1988 - 1989 Corvette: Recall Notice: Rear Wheel Tie Rod

Bulletin No: 89C17

Subject: PRODUCT SAFETY CAMPAIGN 89C17
REAR WHEEL TIE ROD

Model and Year: 1988-89 CHEVROLET CORVETTE

FIGURE 1

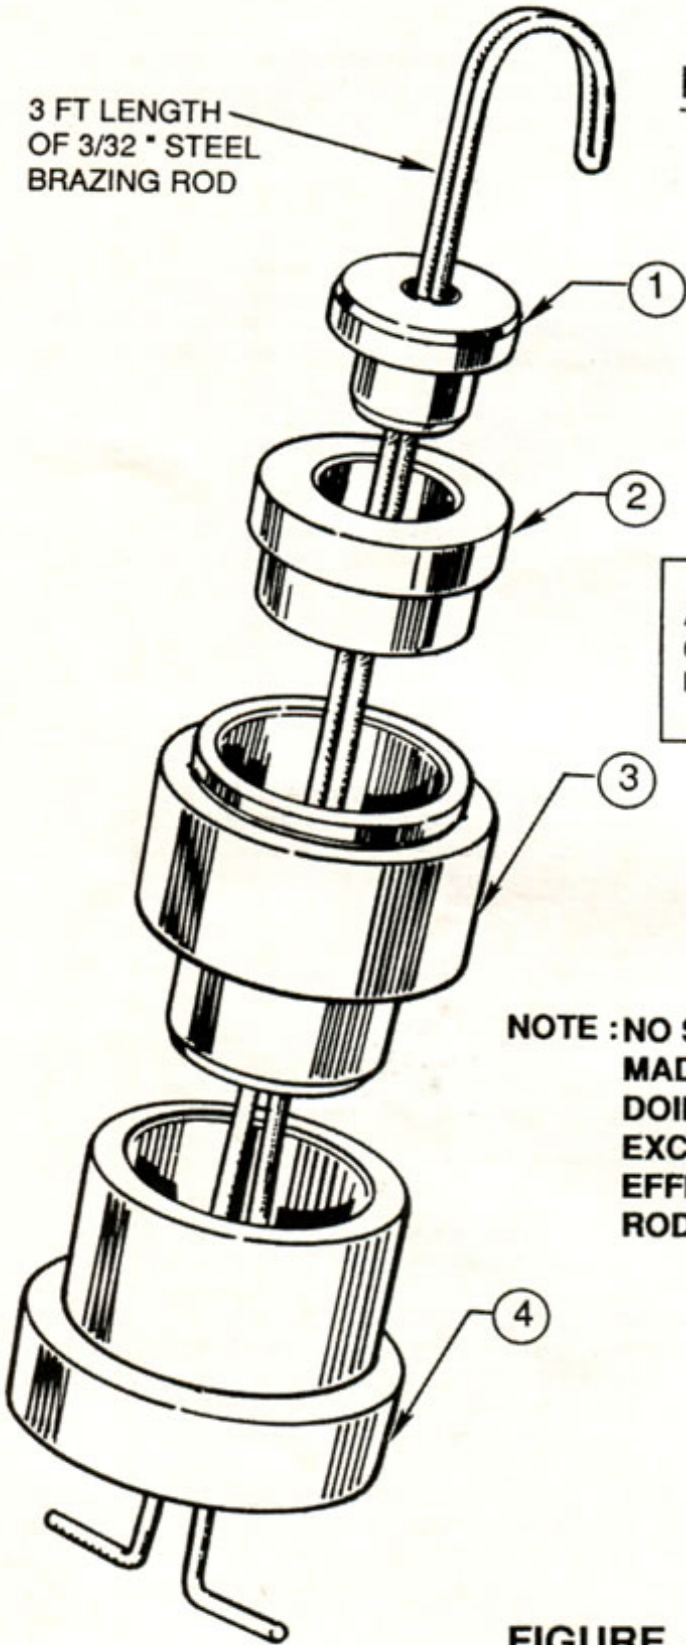
1. Fabricate/Assemble weight from materials indicated and as illustrated in Figure 1.
2. Raise Vehicle.
3. Remove cotter pins, nuts and washers from both outer rear tie rod ends and disconnect from knuckle assemblies utilizing tool J-24319-01.

**NOTE : NO SUBSTITUTIONS SHOULD BE
MADE FOR THE TOOLS INDICATED.
DOING SO, MAY RESULT IN AN
EXCESSIVE WEIGHT WHICH COULD
EFFECT THE ACCURACY OF TIE
ROD INSPECTION.**

FIGURE 2

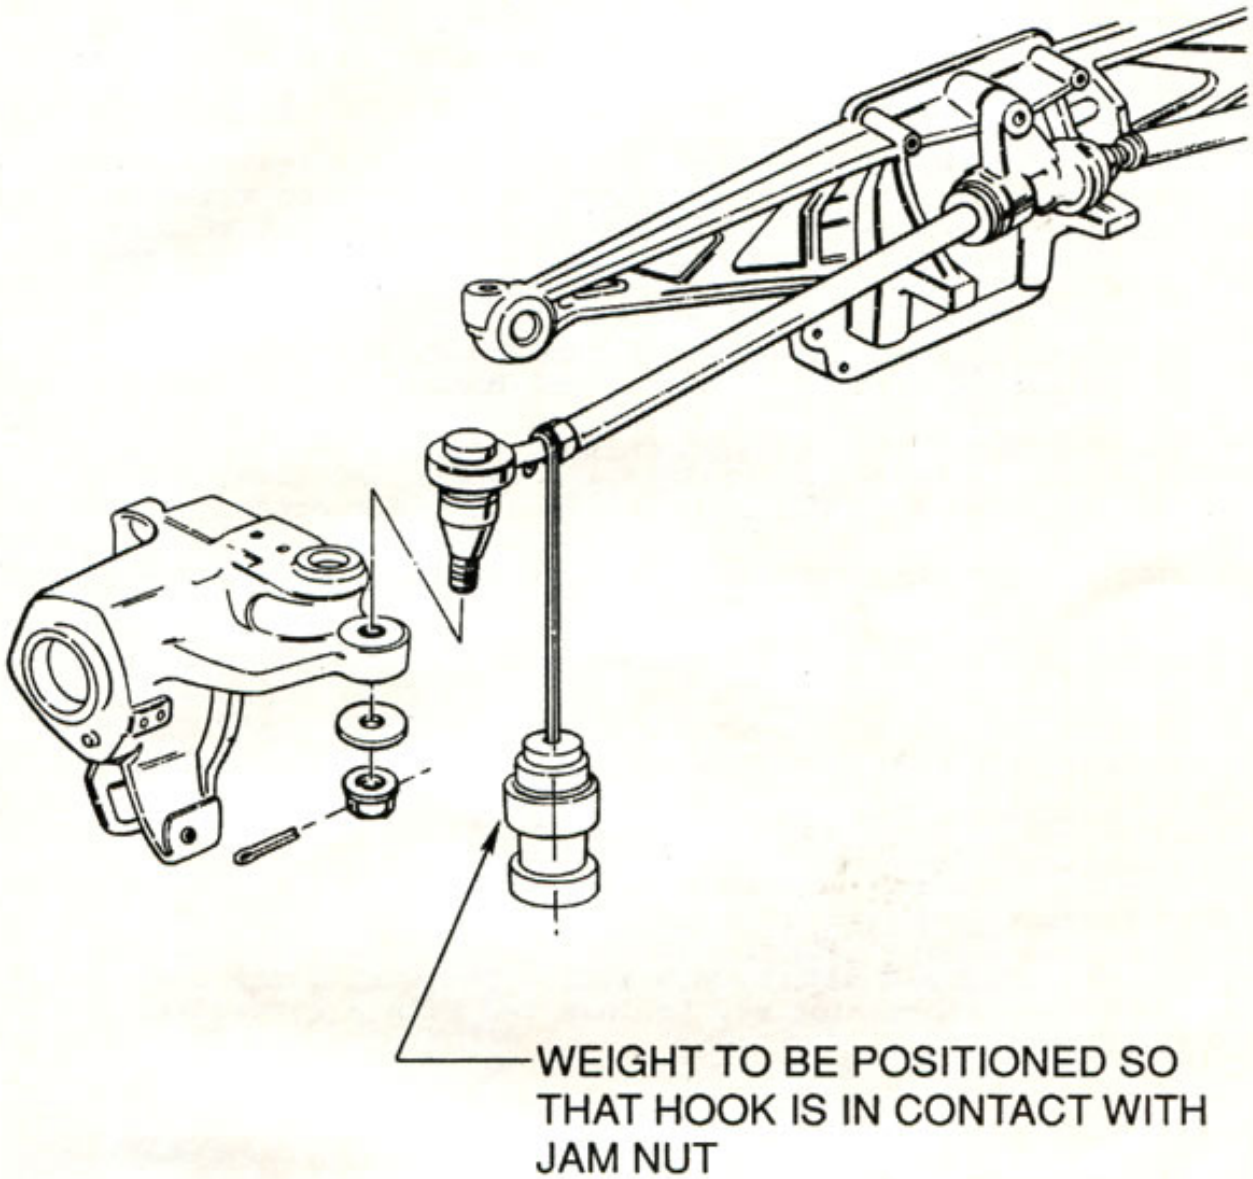
4. Raise and hold outer end of left hand tie rod linkage in its upper most position, insuring rod is not rotated while being raised. Attach weight as shown in Figure 2, release linkage and note results. Repeat procedure on right hand tie rod linkage.
5. Based on observations noted in performing step 4, select appropriate action from those noted below:
 - A. Linkage moves downward on both sides - Reconnect tie rod sockets to knuckles, install washers and nuts, torque nuts to 45 Nm (33 lbs. ft.) and install cotter pins.
 - B. Linkage on either or both sides doesn't move downward - Replace tie rod assembly, transferring existing tie rod ends to new assembly and following Section 3D in the Chevrolet Corvette Service Manual of the appropriate year.
6. Install Campaign Identification Label.

To prevent this condition from occurring, involved vehicles will be inspected to determine the amount of rocking torque on each tie rod. Tie rod assemblies above 12Nm rocking torque on either side will be replaced.
